Office Action Summary	Application No. 10/599,053	Applicant(s) GRAMMELSBERGER, AXEL	
	Examiner /ROBERT J. POPOVICS/	Art Unit 1778

DETAILED ACTION

(19) **United States**
(13) **Patent Application Publication** (10) Pub. No.: **US 2011/0139703 A1**
GRAMMELSBERGER (41) Pub. Date: **Jun. 16, 2011**

(54) **SCREENING GRID** Publication Classification
(75) Inventor: **And GRAMMELSBERGER,** (51) Int. Cl. **B01D 33/04** (2006.01)
Rodgau (DE) (52) U.S. Cl. **210/400**
(21) Appl. No.: **10/599,053** (57) **ABSTRACT**
(22) PCT Filed: **Jan. 24, 2006**
(86) PCT No.: **PCT/EP2006/000873**
§ 371 (a)(1),
(2), (4) Date: **Sep. 18, 2006**
(30) **Foreign Application Priority Data**
Mar. 19, 2004 (DE) **10 2004 014 9227**

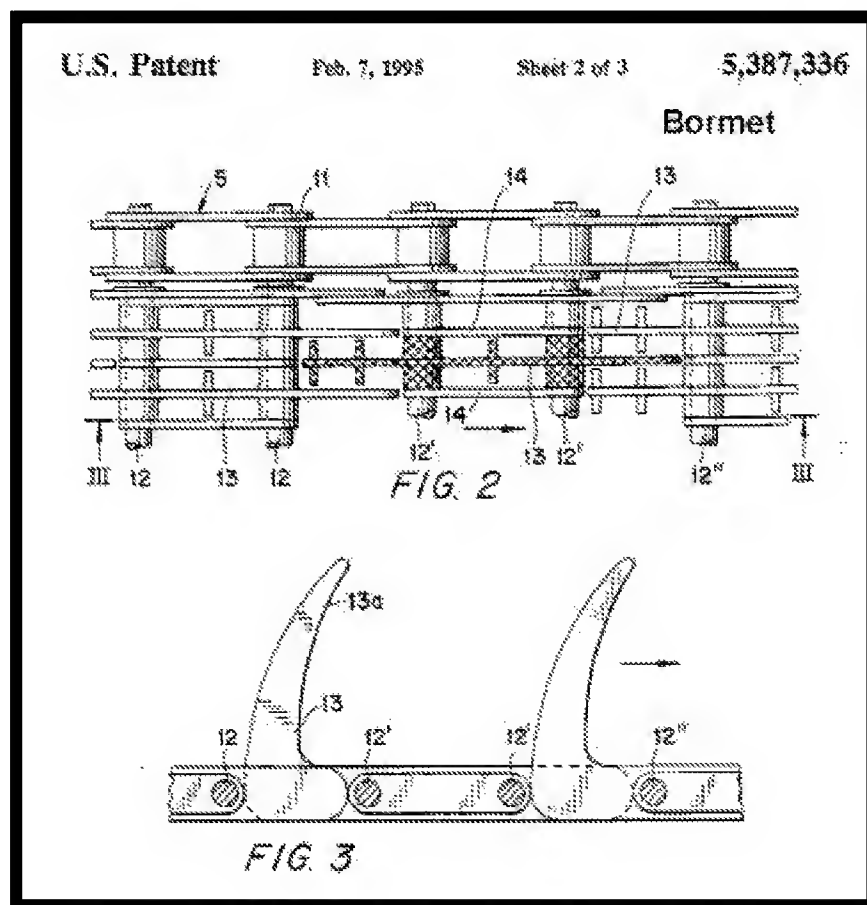
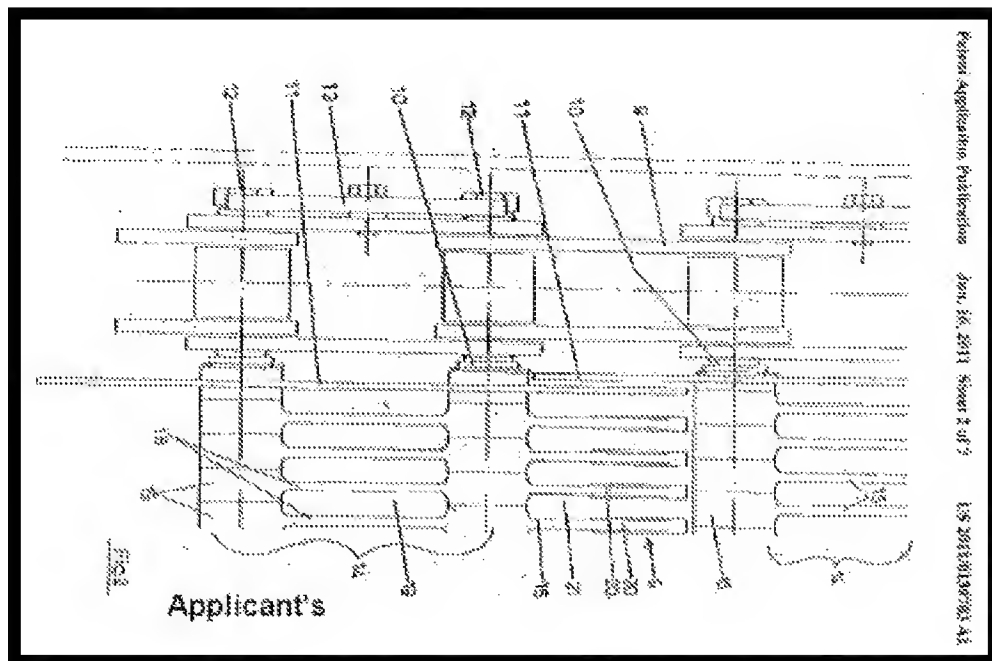
The drawings are objected to because **it is not clear from the drawings which parts are solid and which parts are voids (compare Applicant's Figures with those of Bormet below). Applicant's drawings lack the shading and other drawing conventions that permits those skilled in the art to discern the solid structure from the voids. Additionally, the drawings are objected to because they contain copier marks (e.g., black specs, blemishes, etc.) throughout, or are of poor line quality.** Corrected drawing sheets in compliance with 37 CFR 1.121(d) are required in reply to the Office action to avoid abandonment of the application. Any amended replacement drawing sheet should include all of the figures appearing on the immediate prior version of the sheet, even if only one figure is being amended. The figure or figure number of an amended drawing should not be labeled as "amended." If a drawing figure is to be canceled, the appropriate figure must be removed from the replacement sheet, and where necessary, the remaining figures must be renumbered and appropriate changes made to the brief description of the several views of the drawings for consistency. Additional replacement sheets may be necessary to show the renumbering of the remaining figures. Each drawing sheet submitted after the filing date of an application must be labeled in the top margin as either "Replacement Sheet" or "New Sheet" pursuant to 37 CFR 1.121(d). If the changes are not accepted by the examiner, the applicant will be notified and informed of any required corrective action in the next Office action. The objection to the drawings will not be held in abeyance.

The drawings are objected to under 37 CFR 1.83(a). The drawings must show every feature of the invention specified in the claims. Therefore, ***"wherein all screening links having projecting parts that extend only in one direction,"*** must be shown or the feature(s) canceled from the claim(s). No new matter will be entered.

Corrected drawing sheets in compliance with 37 CFR 1.121(d) are required in reply to the Office action to avoid abandonment of the application. Any amended replacement drawing sheet should include all of the figures appearing on the immediate prior version of the sheet, even if only one figure is being amended. The figure or figure number of an amended drawing should not be labeled as "amended." If a drawing figure is to be canceled, the appropriate figure must be removed from the replacement sheet, and where necessary, the remaining figures must be renumbered and appropriate changes made to the brief description of the several views of the drawings for consistency. Additional replacement sheets may be necessary to show the renumbering of the remaining figures. Each drawing sheet submitted after the filing date of an application must be labeled in the top margin as either "Replacement Sheet" or "New Sheet" pursuant to 37 CFR 1.121(d). If the changes are not accepted by the examiner, the applicant will be notified and informed of any required corrective action in the next Office action. The objection to the drawings will not be held in abeyance.

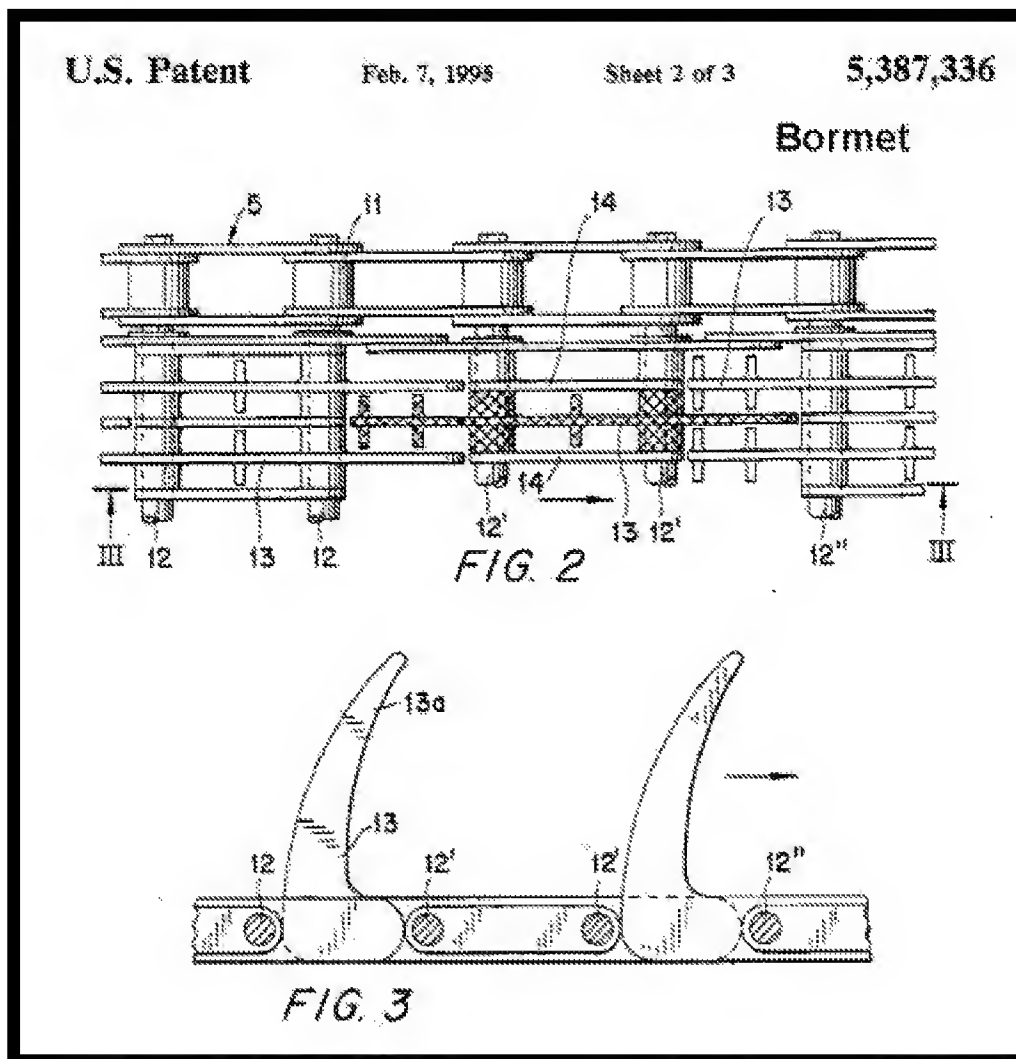
With respect to the recitation, ***"wherein all screening links having projecting parts that extend only in one direction,"*** it is unclear what ***"one direction"*** Applicant intends by this recitation. It is unclear what said extension is relative to. What is the frame of reference with respect to said ***"projecting parts?"*** It is unclear where the claimed ***"projecting parts"*** end or begin. It is unclear where the ***"at least partially have hooks"*** begin. It is unclear what Applicant intends by a **partial hook**? It is unclear how the ***"projecting parts"*** differ from the **partial hooks**, or where the ***"projecting parts"*** end and the **partial hooks** begin. The recitation, ***"at least partially have hooks"*** is relative and subjective, causing numerous possible interpretations of said recitation, thus rendering the claim vague and indefinite.
